Informal document GRB-63-07
(63rd GRB, 16-18 February 2016,
agenda item 9)

Proposal for Amendments of Regulation No. 63

Regulation No. 63

Figure 1: Measuring positions for vehicles in motion

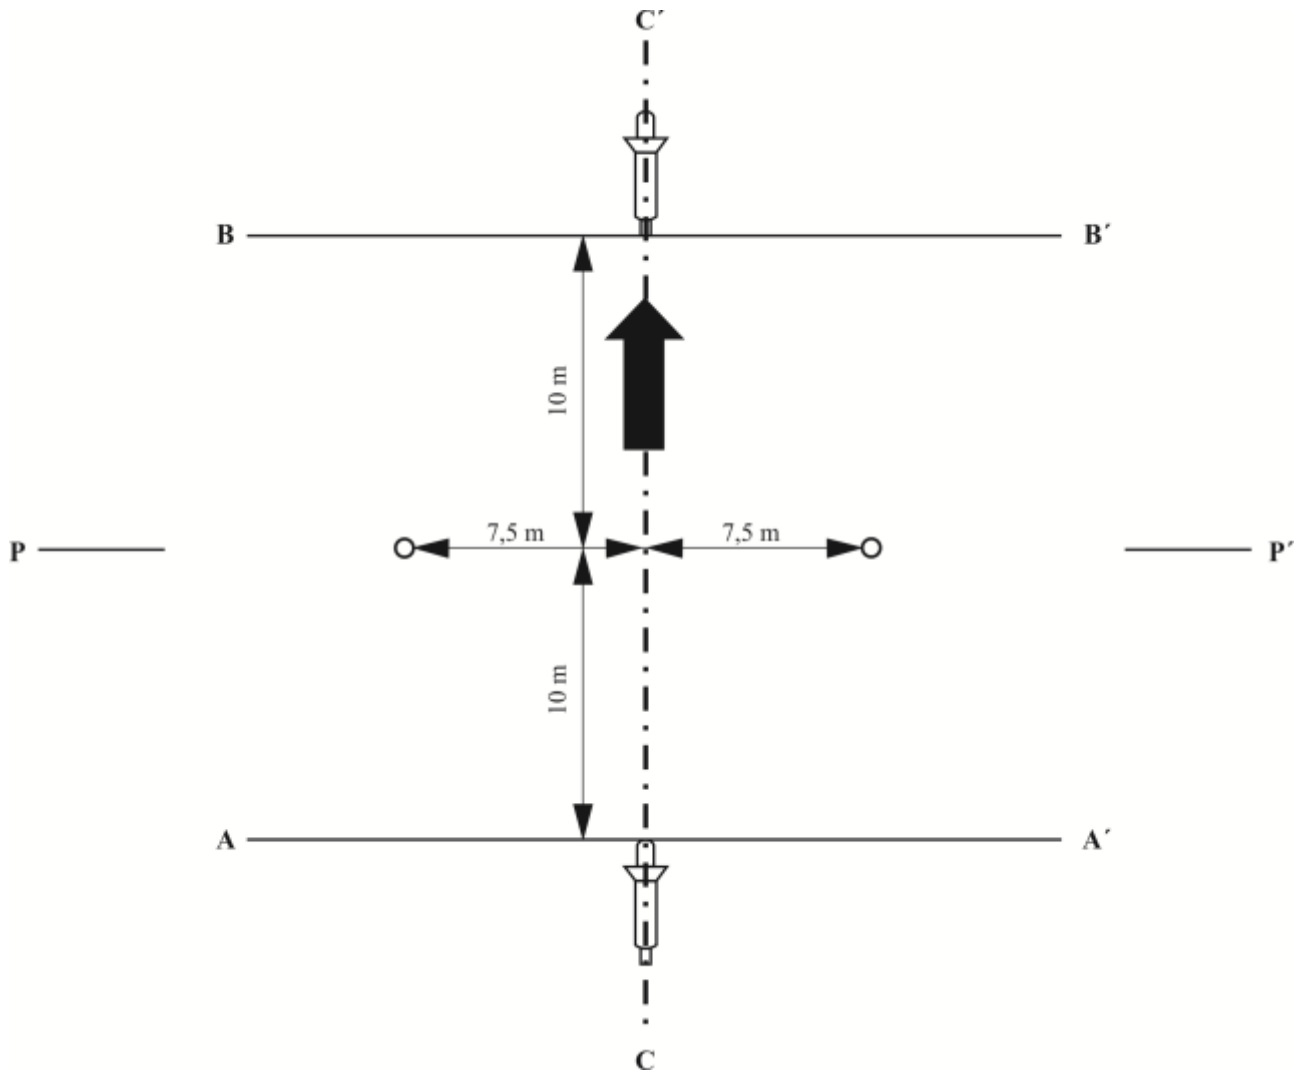
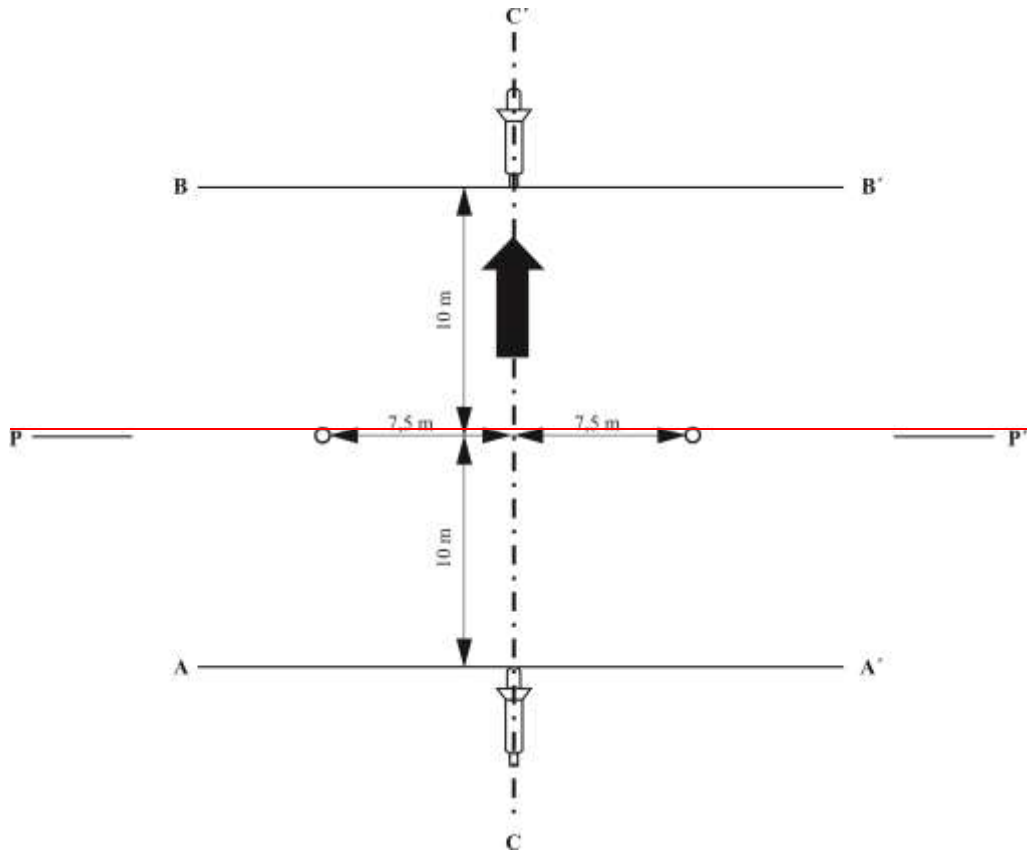
- 3.1.1.1. The test arrangement is shown in figure 1.
- Two lines, AA' and BB', parallel to the microphone line PP' and situated respectively 10 m forward and 10 m rearward of that line shall be marked out on the test track.~~At least two measurements shall be made on each side of the moped.~~

- ~~Preliminary measurements may be made for adjustment purposes, but shall be disregarded.~~
- 3.1.1.2. The distance of the microphone positions from the line CC', on the microphone line PP', perpendicular to the reference line CC' on the test track (see ~~appendix~~, Figure 1), shall be 7.5 ± 0.05 m.

Figure 2: Measuring positions for the measurement of sound of the stationary vehicles

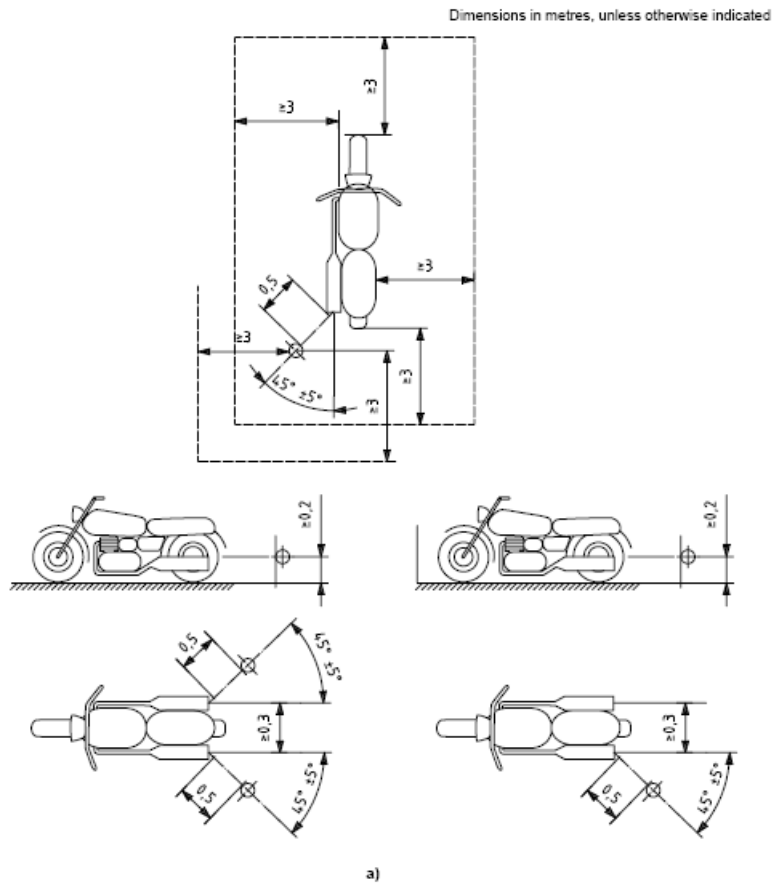
- 3.2.3.3. Measuring of ~~noise~~sound in proximity to the exhaust
- 3.2.3.3.1. Position of the microphone ~~(see figure 2)~~
- The microphone shall be located at a distance of 0.5 ± 0.01 m from the reference point of the exhaust pipe defined in Figure 4-3 and at an angle of $45^\circ \pm 5^\circ$ to the vertical plane containing the flow axis of the pipe termination. The microphone shall be at the height of the reference point, but

Figure 3: —Reference point

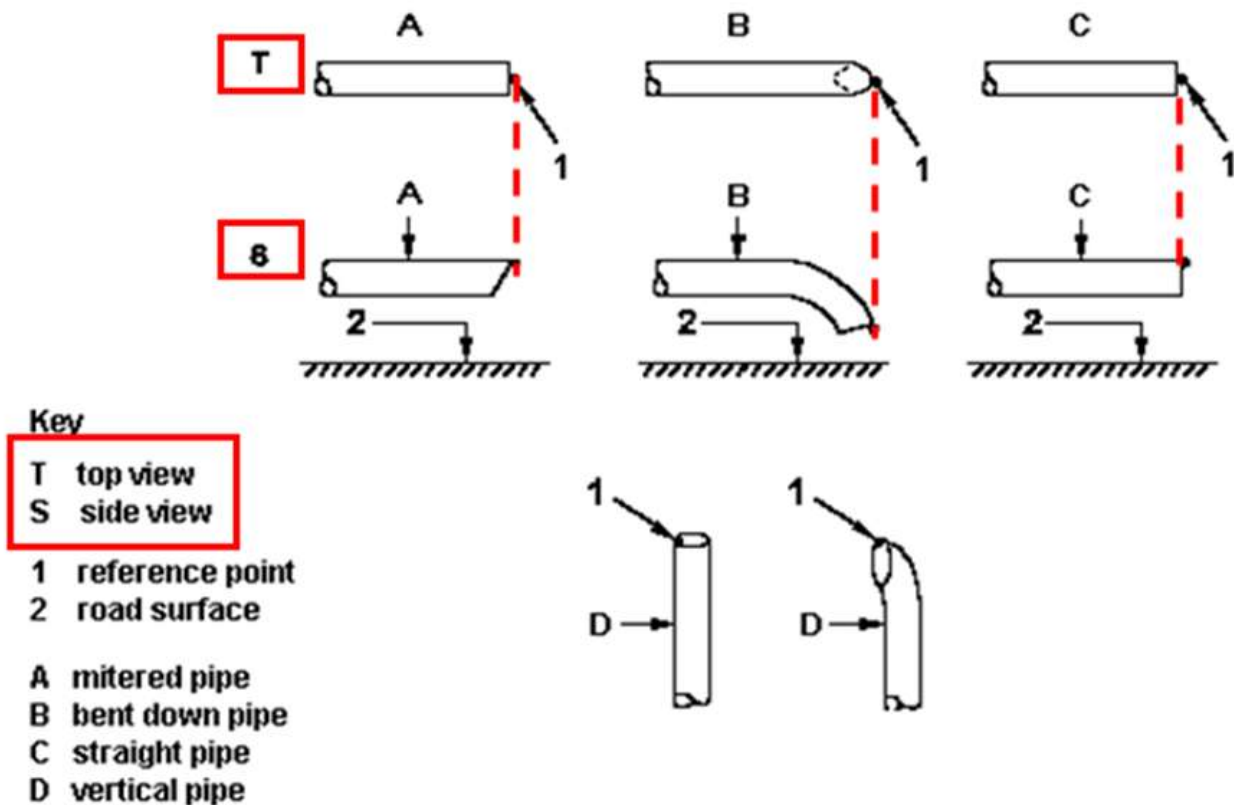
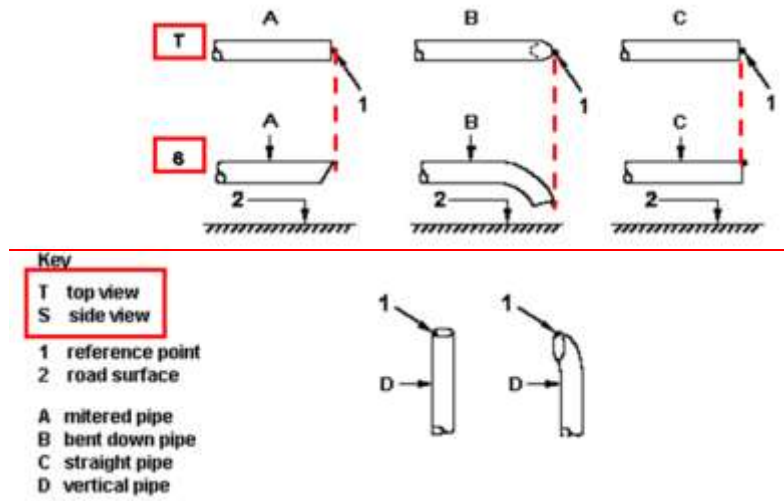
The reference point shall be the highest point satisfying the following conditions:

- The reference point shall be at the end of the exhaust pipe;
- The reference point shall be on the vertical plane containing the exhaust outlet centre and the flow axis of the exhaust pipe termination.
